MIDLAND ENERGY CENTER  
MIDLAND DOCKET NOS 50-329, 50-330  
NRC REQUEST FOR ADDITIONAL INFORMATION ON THE  
SEISMIC MARGIN REVIEW REPORT  
FILE: B3.7.1 SERIAL: 25479

REQUEST FOR ADDITIONAL INFORMATION

130.29 Provide the following additional information with respect to Volume VI of the Seismic Margin Review report titled, "Borated Water Storage Tank and Foundation" transmitted by your letter of February 16, 1983.

FIGURE Q&R 130.29.1-1 TOP-OF-FILL SME RESPONSE SPECTRUM

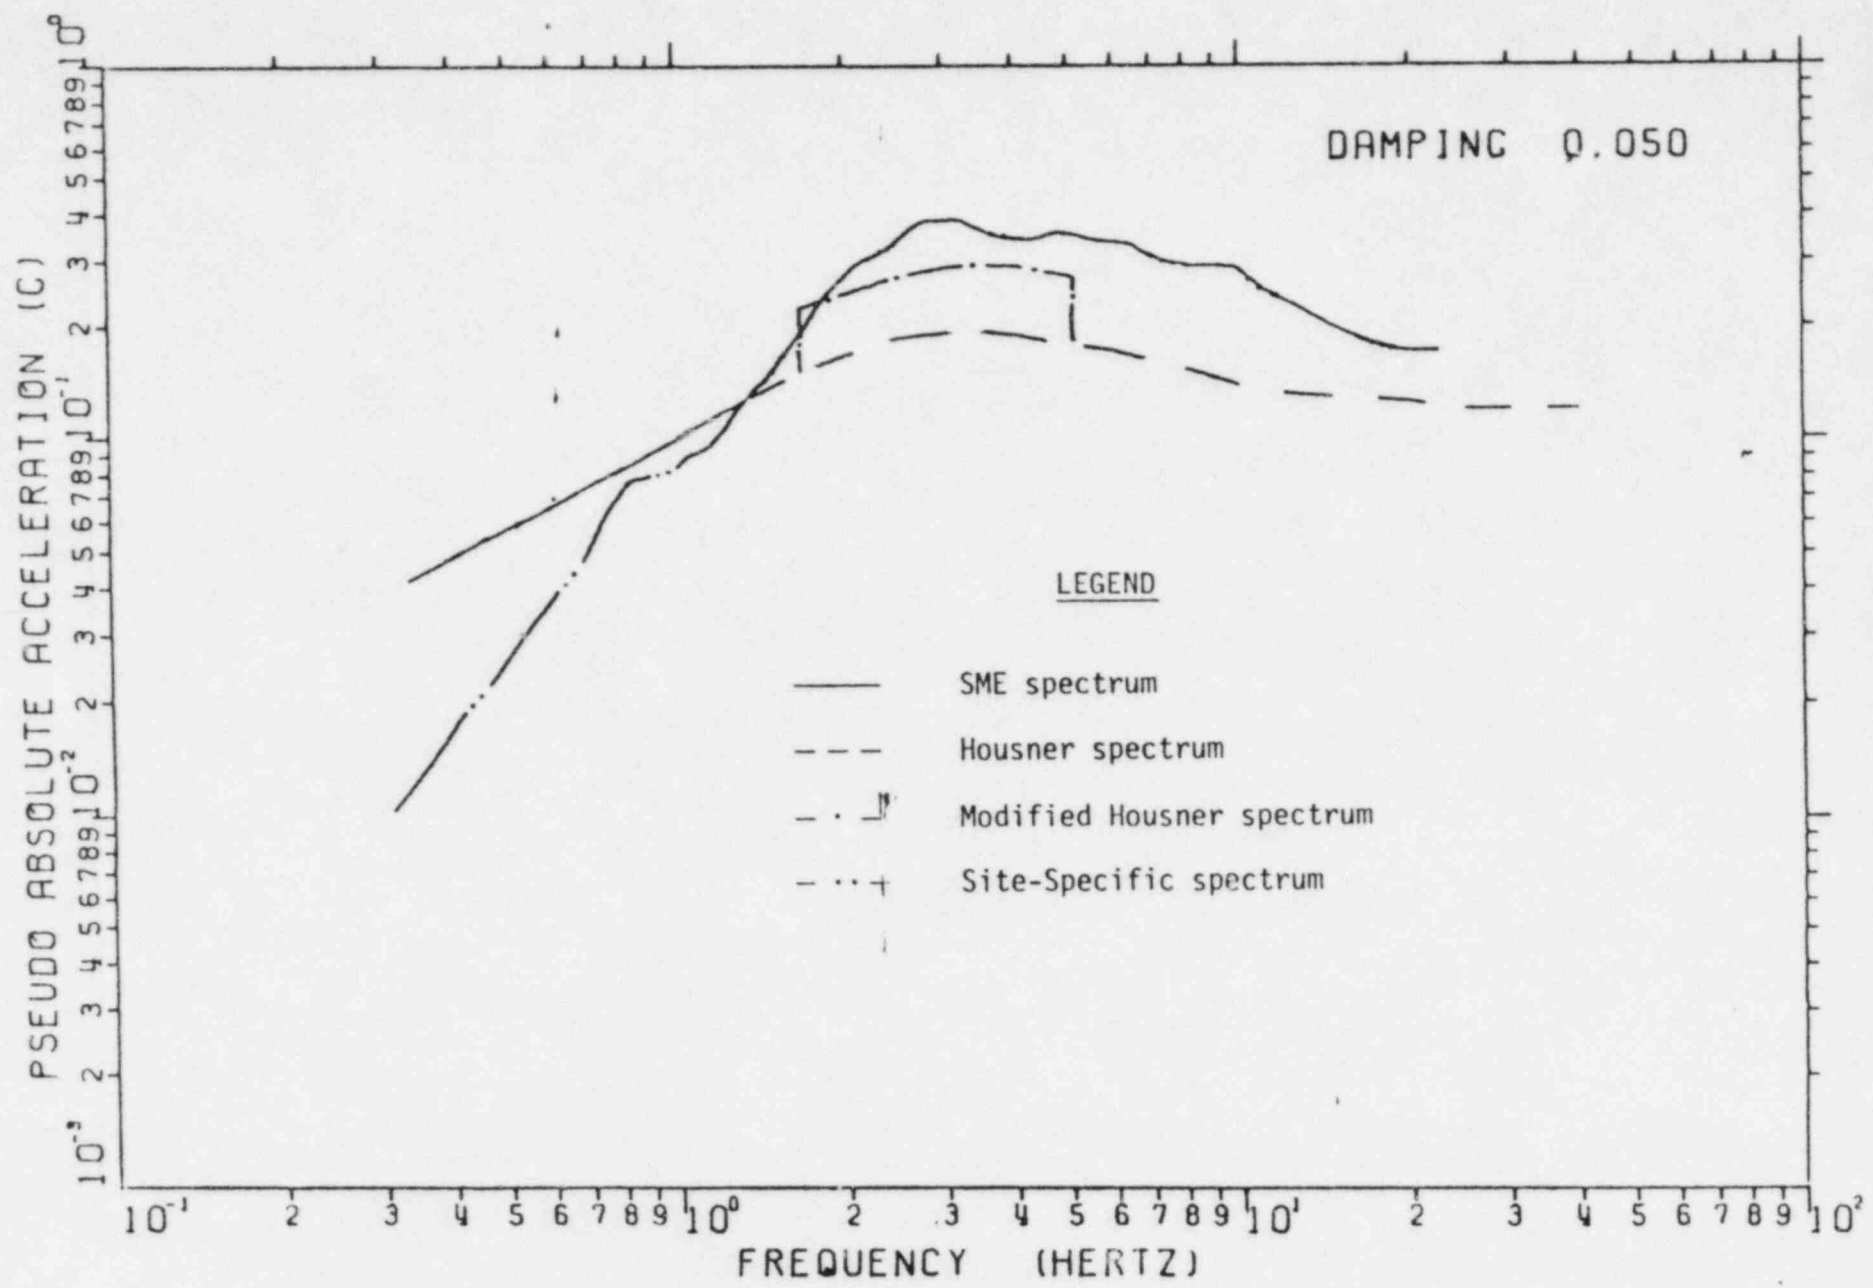
Question 130.29.1 Clarify in Section 1.1 that a modified Housner response spectrum is used in the development of the SME and not just the Housner response spectrum.

Response: The SME response spectrum used for the structural evaluation of the BWST was the envelope of the Housner spectrum and the site-specific response spectrum developed for structures founded at the top-of-fill at the Midland site. Clarification of the use of the Housner spectrum versus the modified Housner for the SME occurred during cross-examination of Dr. Richard J. Holt before the Atomic Safety and Licensing Board on October 13, 1981 (Reference 1). During this testimony it was specifically stated that the original Housner spectrum and not the modified Housner spectrum would be used in the development of the SME spectrum. The SME, site-specific, Housner, and modified Housner response spectra are illustrated in Figure Q&R 130.29.1-1.

For this SME evaluation, it is appropriate to utilize earthquake response spectra which are representative of actual earthquakes which might occur at the Midland site (with low probability of being exceeded). The site-specific response spectrum is representative of actual earthquake motion although it has been broadened to account for uncertainties in earthquake frequency content and site conditions. The Housner spectra, which is the envelope of spectra from actual earthquake time histories, is included in the SME definition to assure that conservative earthquake ground motion is accounted for in the low frequency regime. The Modified Housner response spectrum is unrealistic because no real earthquake ground motion would produce this response spectrum.

FIGURE Q&R 130.29.3-1 COMPARISON OF ACTUAL AND APPROXIMATE HYDRODYNAMIC PRESSURE DISTRIBUTIONS FOR VARIOUS TANK MODE SHAPES

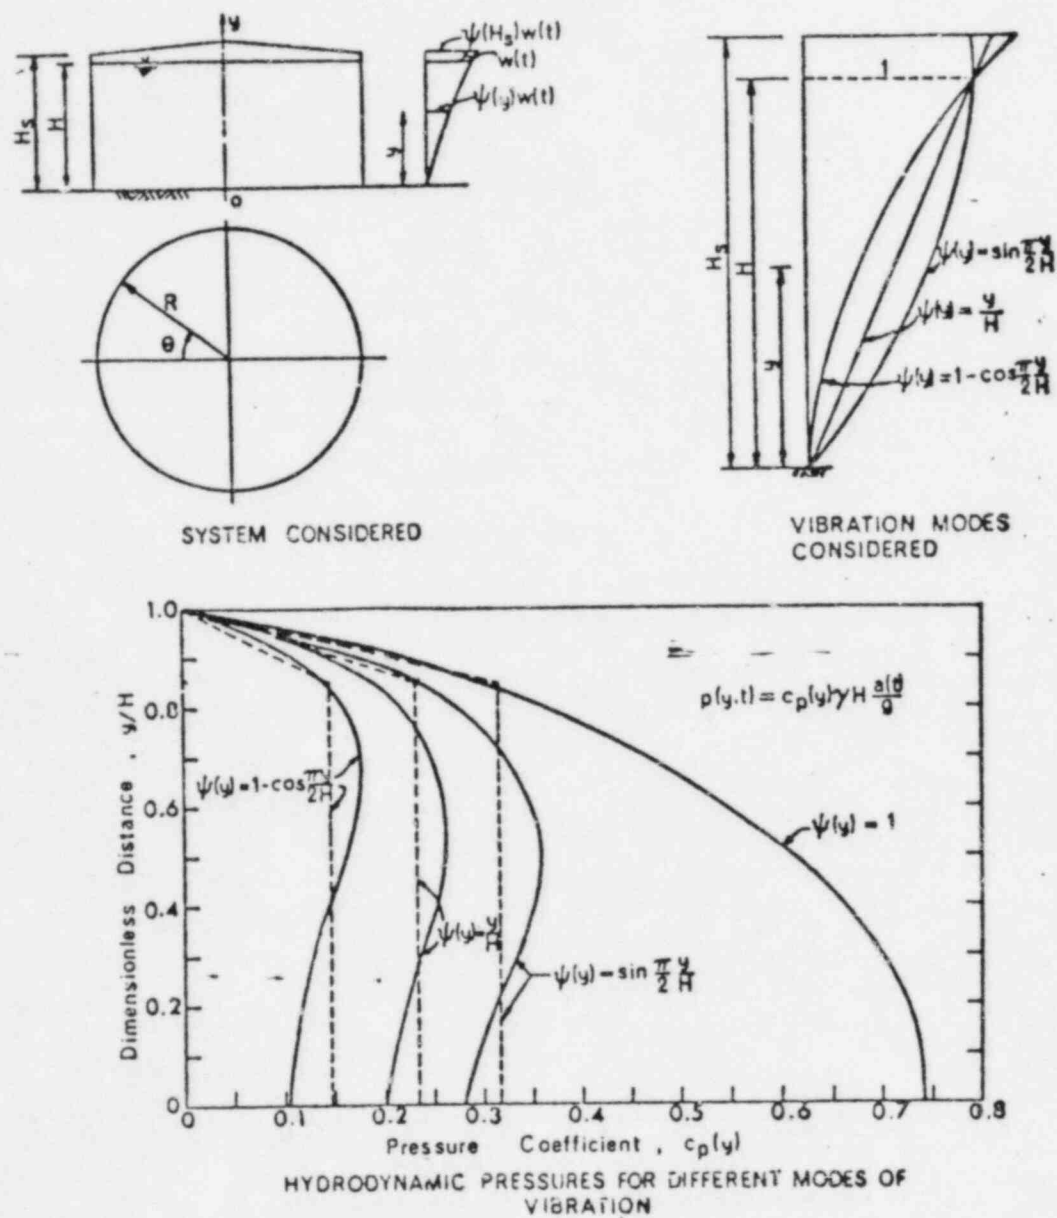
- a. Discuss in more detail why the model identified in Figure VI-2-2 is a better representation than the model in Figure VI-2-1.
- b. State why you assume that the hydrodynamic pressure is constant from elevation  $y = 0.15h$  to the bottom of the tank.
- c. Provide a comparison between the methods identified in References 6 and 7. A summary of specific assumptions, model and results should be provided for staff review.
- d. Address the development of the constant 1.453 in Equation 2-3.
- e. Address Equation 2-4 by providing a specific reference within Reference 2 and/or providing a copy of related pages.

- a. Figures VI-2-1 and VI-2-2 do not represent separate models for evaluating BWST horizontal impulsive mode response. Figure VI-2-1 is shown for the purpose of illustrating how the impulsive fluid mass is lumped to the various degrees of freedom in the model. Figure VI-2-2 provides the actual numerical values describing the model in detail including weights, dimensions, and beam and soil spring properties.
- b. The idealized hydrodynamic pressure distribution in which the pressure increases linearly from zero at the top of the fluid ( $y = 0$ ) to the constant value from Equation 2-3 at  $y = 0.15$  and greater is based on the recommendation of Reference 6. This distribution is a reasonable approximation as shown in Figure Q&R 130.29.3-1 (reproduced from Reference 6) by the comparison of actual and the approximate distribution for different tank mode shapes.

FIGURE Q&R 130.29.4-1 EFFECT OF ACCOUNTING FOR VERTICAL TANK/FLUID FLEXIBILITY

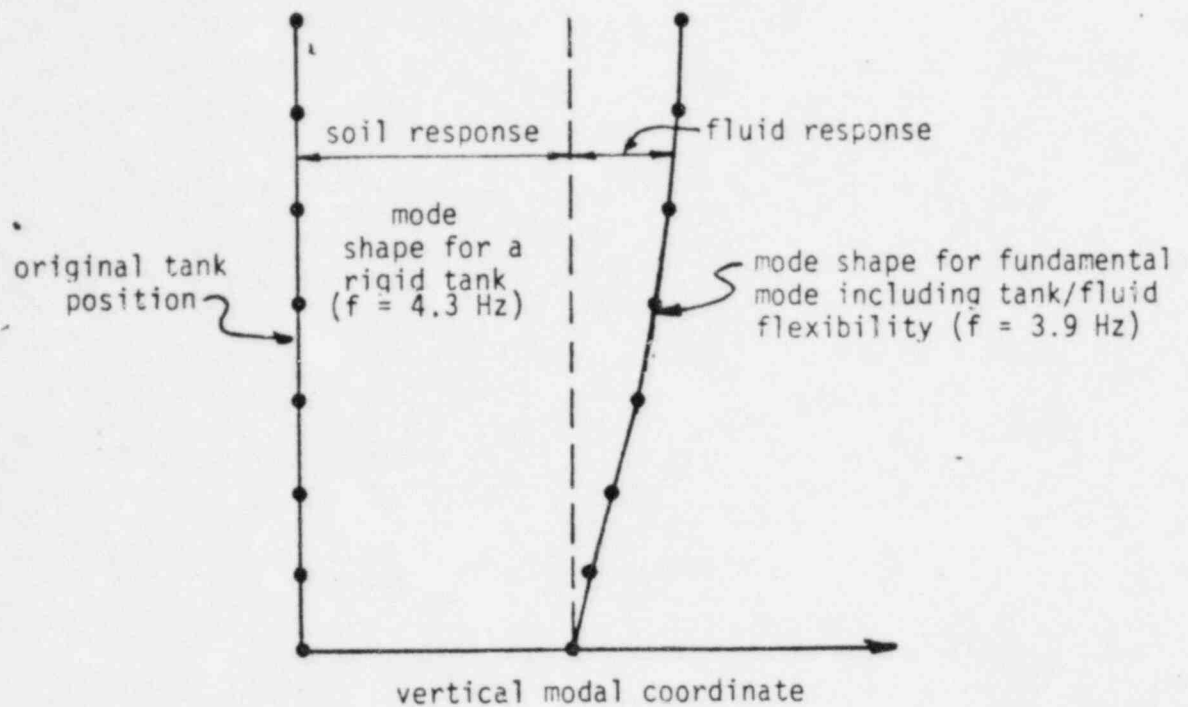
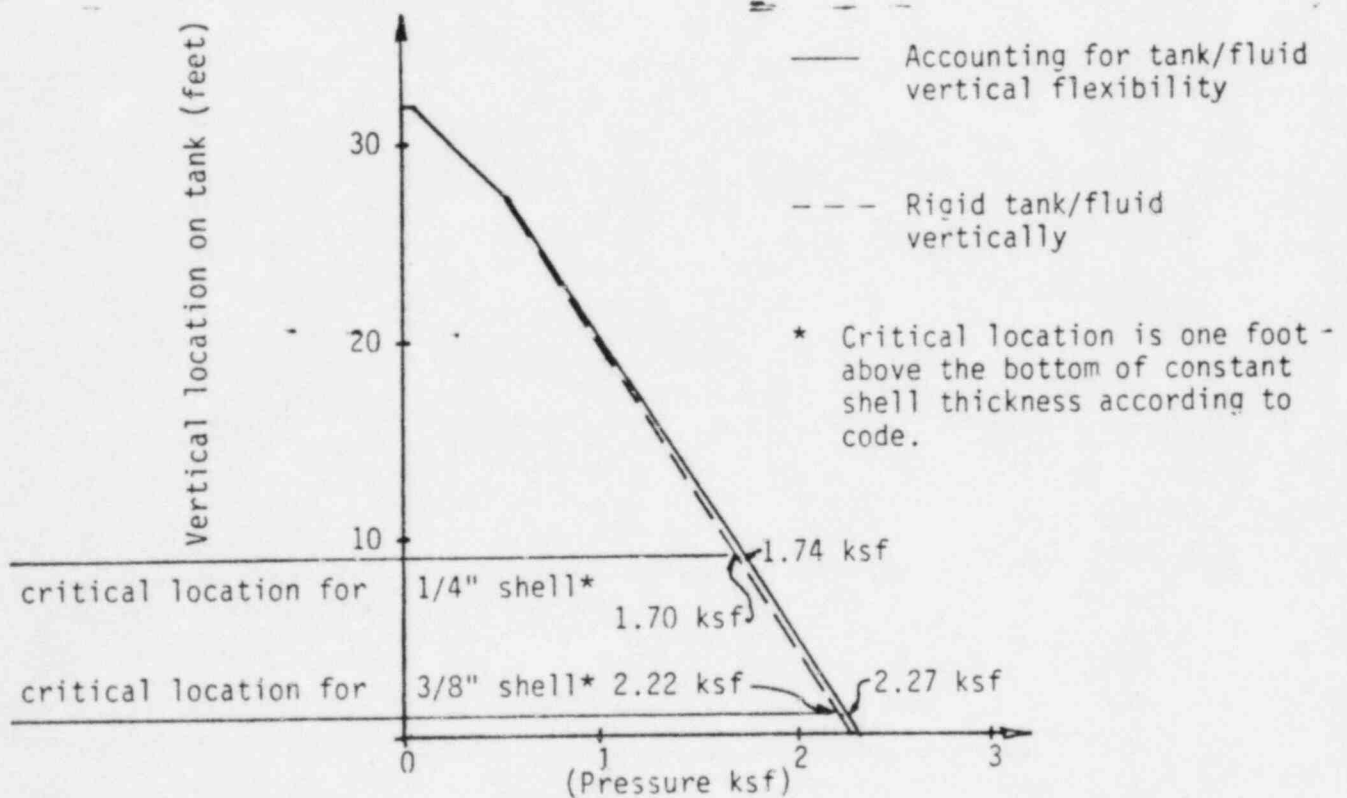
Question 130.29.4 With respect to Section 2.2.3, investigate and discuss results of the effect on the fundamental frequency and hydrodynamic pressures due to vertical ground motion for the borated water storage tanks.

The coupled tank-fluid-soil response for vertical seismic excitation has been computed by a model consisting of spring elements representing the tank and fluid which produce a fixed-base fundamental frequency of about 8.1 Hz and which is attached to ground by a vertical soil spring. The lower bound soil case is considered as this case produced the largest seismic response for horizontal excitation. The mode shapes and total wall pressures (i.e., combined hydrostatic and hydrodynamic pressures) are compared in Figure Q&R 130.29.4-1 for the rigid tank approximation and including tank/fluid vertical flexibility.

The results presented above indicate that the rigid tank approximation was adequate for the BWST evaluation. Although the vertical fundamental frequency is overestimated by about 10 percent, the maximum tank shell pressure (i.e., combined hydrostatic plus hydrodynamic pressures) is underestimated by only about 2 percent. The resulting minimum hoop stress code margin, CM, and seismic margin,  $F_{SME}$ , as reported in Section 4.4.2, are changed from 2.13 and 8.40 to 2.08 and 7.28, respectively, when vertical flexibility is accurately accounted for. Thus, the conclusions of the BWST report are not significantly affected by the rigid tank approximation for vertical ground motion.
